GTS NEWSLETTER

TASKI swingo XP

Subassembly: Base

Squeegee lowering

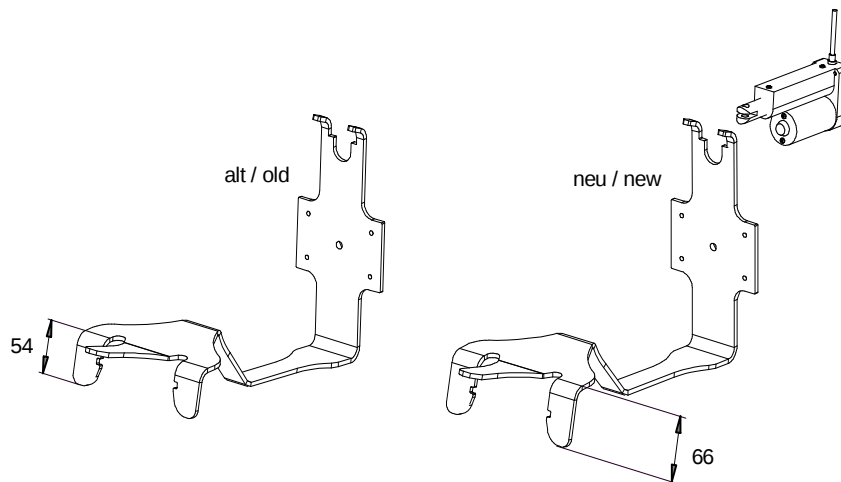
To ensure a more reliable contact pressure of the squeegee on the floor, an extended swinging arm and a stronger linear drive was introduced.

The lugs of the swinging arm were enlarged from 54 to 66 mm.

- Instead of the old swinging arm, a new swinging arm and a new linear drive will now be delivered
- The new parts are available as single parts from stock
- With immediate effect, the old parts are not available anymore

- The correct functioning of the new swinging arm is ensured only when using the new linear drive
- The new linear drive works perfectly with the new as well as with the old swinging arm
